MISSISSAUGA BUS RAPID TRANSIT

ENVIRONMENTAL ASSESSMENT ADDENDUM

March 2010

McCormick Rankin Corporation
in association with
Ecoplans, Ltd.

RECOMMENDED ALTERNATIVE
EASTGATE PARKWAY / FIELDGATE DRIVE

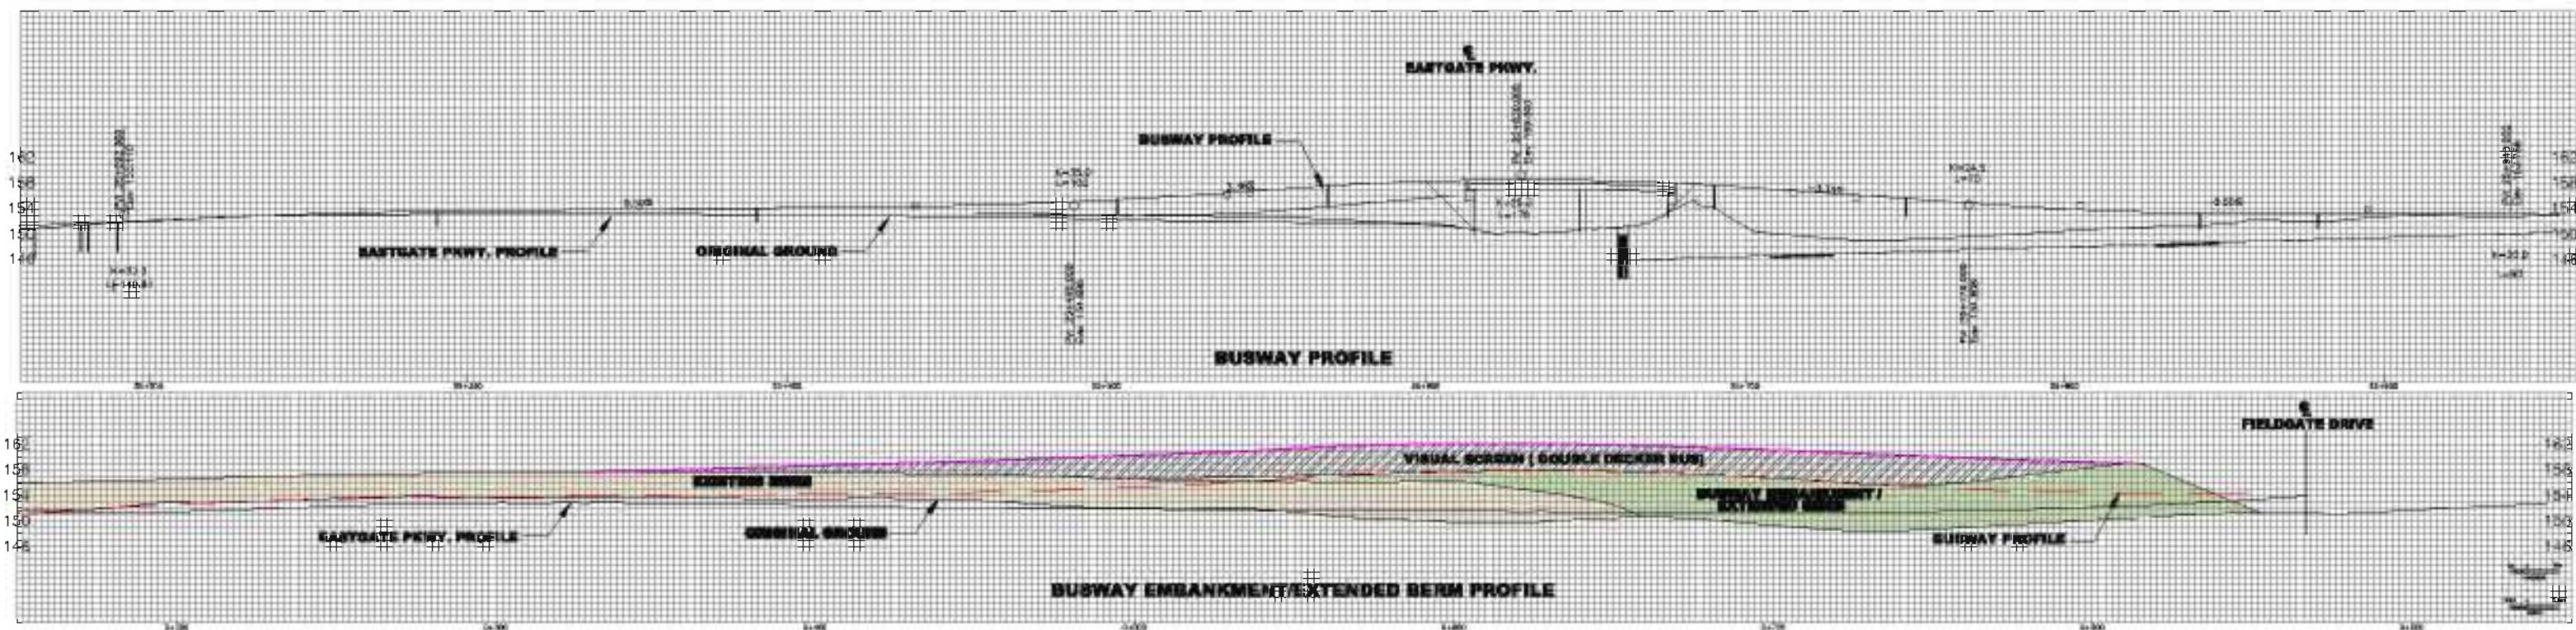
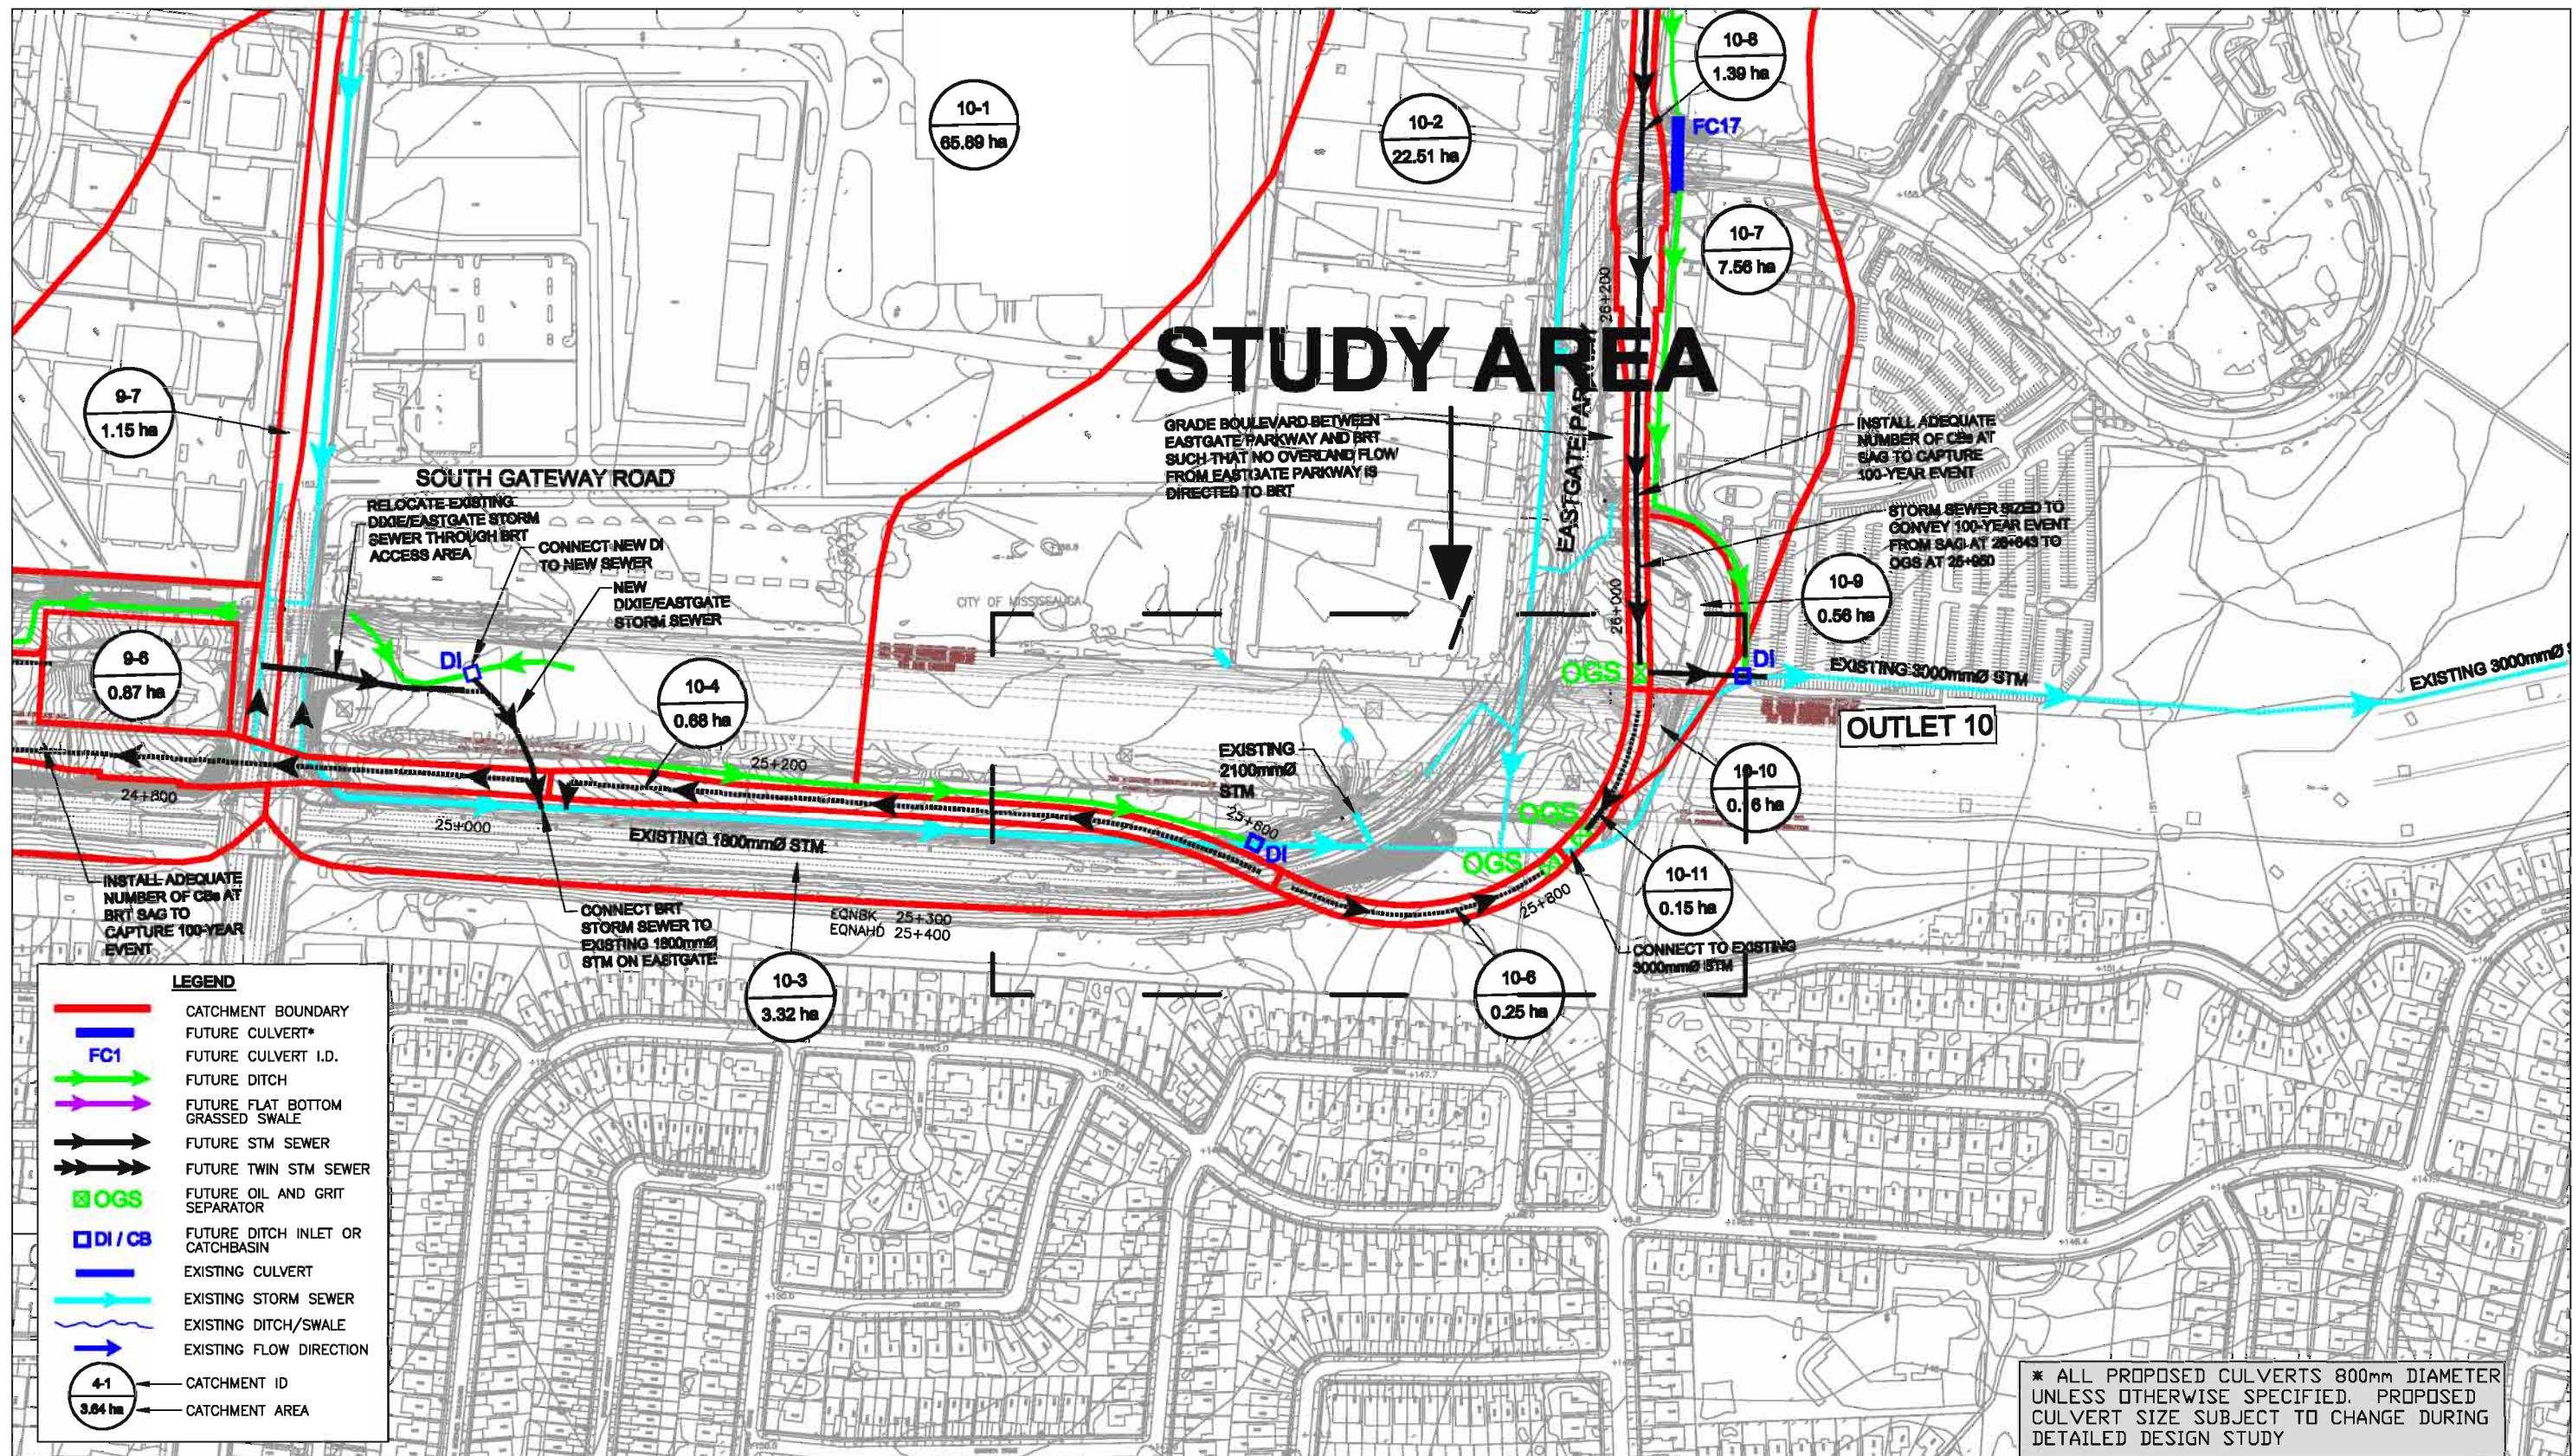
- Lower the busway so as to cross under the pipelines (requiring their suspension in a bridge structure across the busway cut)
- Shift the undercrossing of Eastgate Parkway westerly to allow the busway to rise over the pipelines then down under Fieldgate; or
- Elevate the busway over Eastgate Parkway, returning to grade at the pipelines and dropping under Fieldgate (see Figure 9-2).

The proposed alternative is to take the busway over Eastgate Parkway, over the pipelines, and under Fieldgate Drive. Particular attention is required to mitigating the effects of the new facility on the existing residential area to the south, by improving the existing berm and installing visual screening. The recommended alternative is shown on Figure 9-2.
